E4418B-07A

S E R V I C E N O T E

Agilent E4418B EPM Power Meter

Premature RAM Backup Battery Failure

Figure 2. Location of Surface Mount Resistors

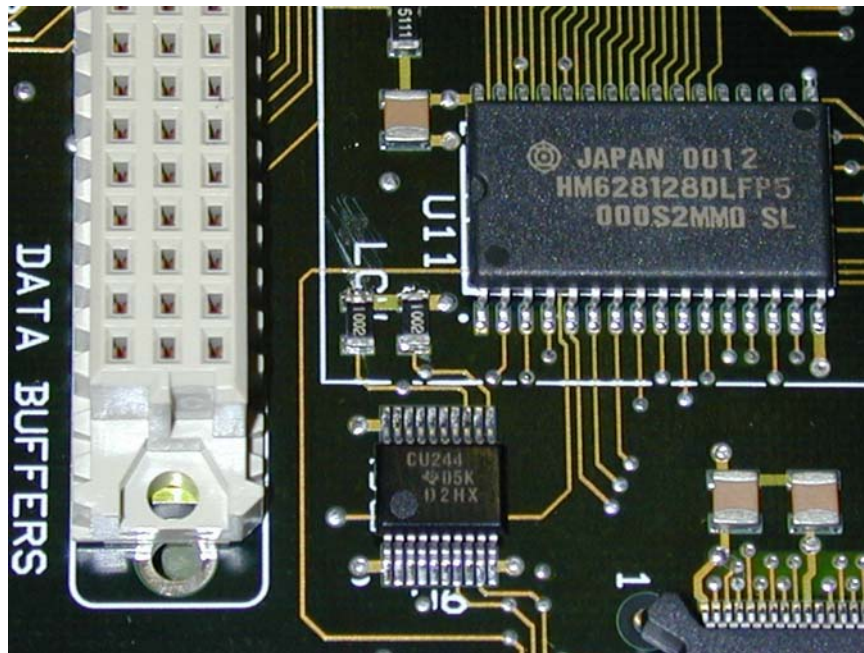
- Processor Assembly revisions prior to 'S' are not covered by this service note. RAM backup battery failures on these boards may be detailed in a previous service note, or they may simply be caused by natural aging of the unit. Check other service notes for this unit to verify this failure mode is not likely to be caused by any other documented problems. Do not carry out steps 4 to 14.
- Locate the two surface mount pull-up resistors (see Figure 2).

Figure 3. Surface Mount Resistors Removed from Board

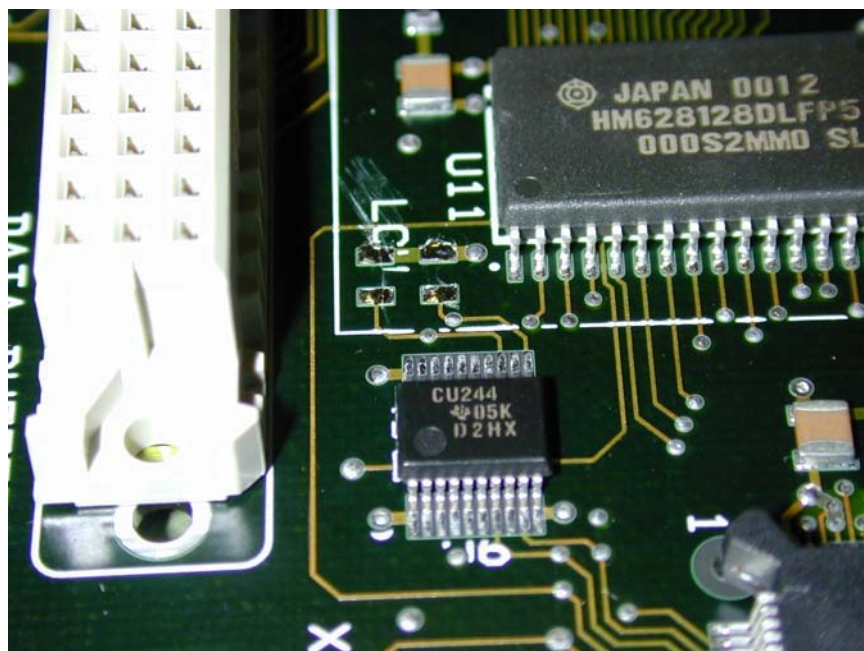
- Remove the two surface mount pull-up resistors (see Figure 3).
